**PLANNING COMMITTEE MEETING**

**Wednesday 8 May 2019**

**Item: 8.1**

**Eight (8) lot subdivision, associated works and native vegetation removal at 3036 Colac Forrest Road, Forrest**

**PLAN OF PROPOSED SUBDIVISION & BUILDING AND EFFLUENT ENVELOPES**  
**CROWN ALLOTMENTS 5J(Pt), 5J1 & 5X(Pt)**  
**SECTION A**  
**PARISH OF YAUGHER**  
**COUNTY OF POLWARTH**  
**RE: NEWLANDS PASTORAL CO.**  
**SCALE 1:1250** (Original Sheet Size A3)

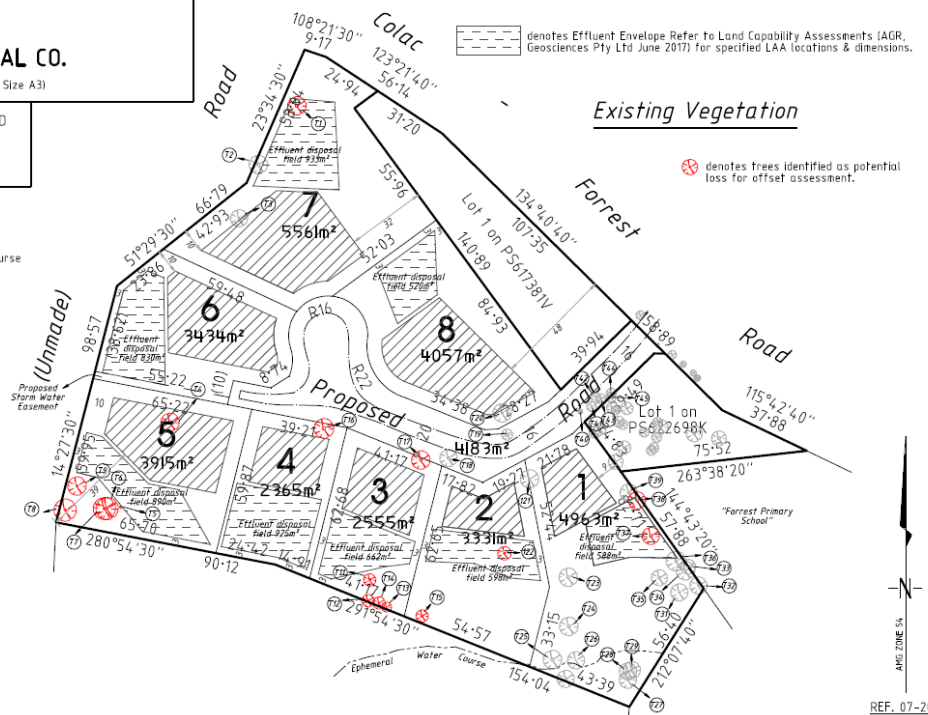
- 1. The proposal fails to provide an adequate drainage and effluent disposal design taking into account the topography of the land, the presence of an ephemeral waterway and the density of the development.***

- 2. The proposed subdivision fails to adequately address the requirements of Clause 56.07-4 (Urban Runoff Management Objectives) of the Colac Otway Planning Scheme, which seeks to minimise inconvenience to residents from urban runoff and to ensure that the street operates adequately during major storm events and provides for public safety.***

- 3. The proposal fails to adequately address the requirements of Clause 56.07-3 (Waste Water Management Objective) of the Planning Scheme, which seeks to provide a waste water system for the lots that is adequate for the maintenance of public health and the management of effluent in an environmentally friendly manner.***

- 4. The proposed vegetation loss fails to comply with the application requirements specified in the 'Guidelines for the removal, destruction or lopping on native vegetation' (Department of Environment, Land, Water and Planning, 2017) as set out in Clause 52.17 (Native Vegetation) of the Planning Scheme.***

- B. *Council considers the subdivision of the subject land into residential lots to be acceptable and appropriate in principle, subject to drainage and wastewater concerns being appropriately addressed (which may require a reduction in the number of lots).***

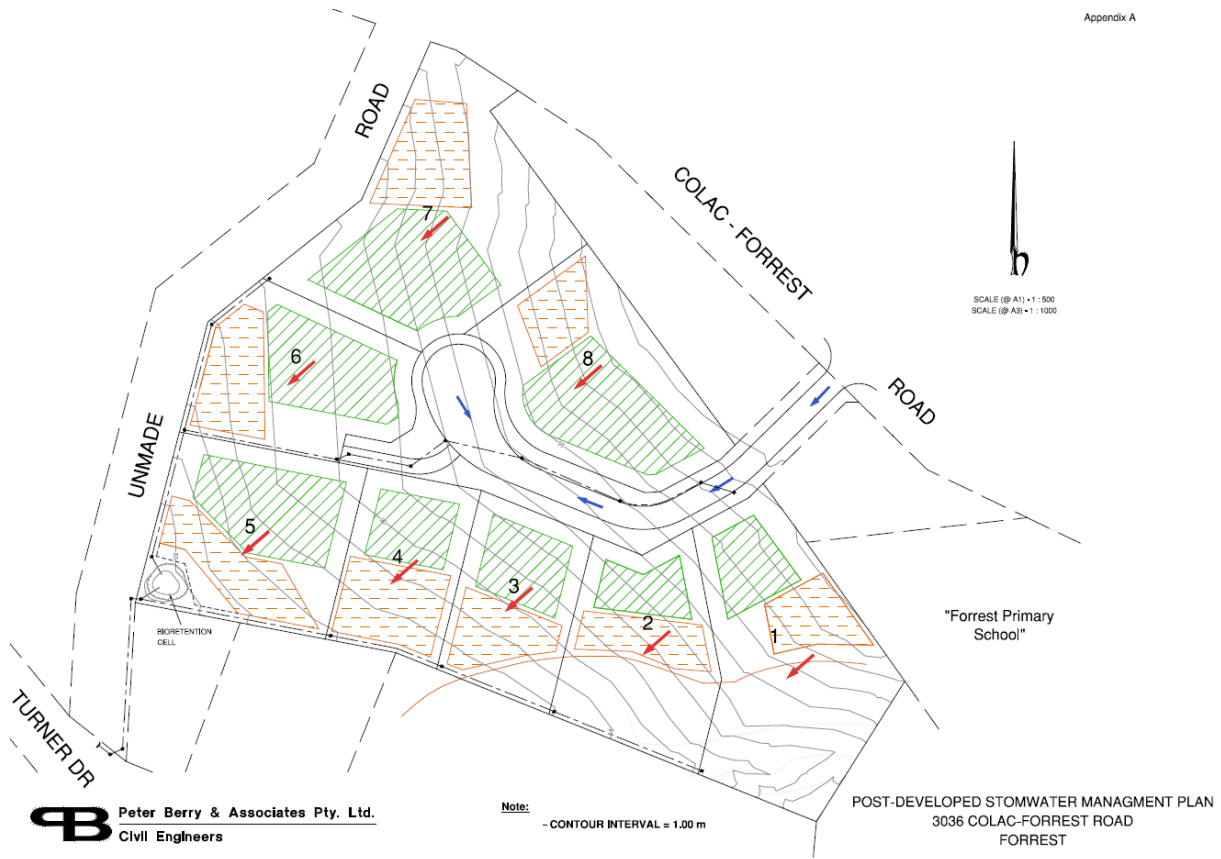
Council's Infrastructure Unit considered that the cost on Council to 'reset' the bio-retention cell would be large. It is not considered that Council should bear this cost and the applicant has not advised how this maintenance cost would be funded. Council does not want to enter into a special charge scheme in the future as this would be onerous if there are other options that could be presented by the applicant.

Council's Infrastructure Unit has also expressed concerns about the nominated discharge to be directed to the bio-retention area having regard to the IDM. It was noted that by choosing to treat only a portion of the discharge, the percentage removal to be applied to the treated volume would necessarily rise, to a level that Council's Infrastructure Department believes would be mathematically unachievable. In addition, it was noted that only 1 of the proposed 6 swale drains would provide a gradient within recommended limits as provided by the IDM. To minimise the slope of the drains to achieve this requirement would require significant excavation, altering the existing landform substantially.
